## REMARKS

## VERSION WITH MARKINGS TO SHOW CHANGES MADE

FIG.3

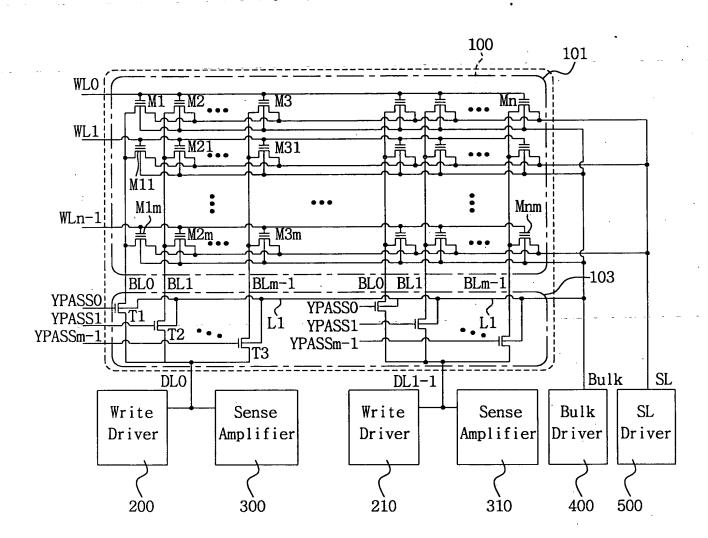
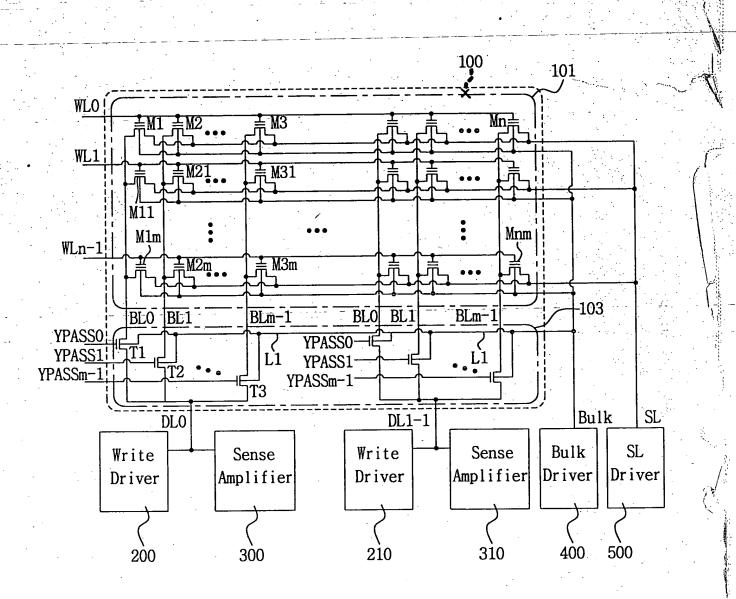
The drawings were objected to as failing to comply with 37 CFR 1.84(p)(5) because they failed to include the reference sign 201. The reference sign 201 appears in the specification as the result of a typographical error. The specification has been amended to replace the reference sign 201 with 210 in both occurrences. In reviewing the drawings, however, it was discovered that the leader line from reference sign 100 extends to the wrong feature in FIG. 3. FIG. 3 has therefore been replaced-with a corrected FIG. 3. A redline version of the drawing is included herewith to indicate the change.
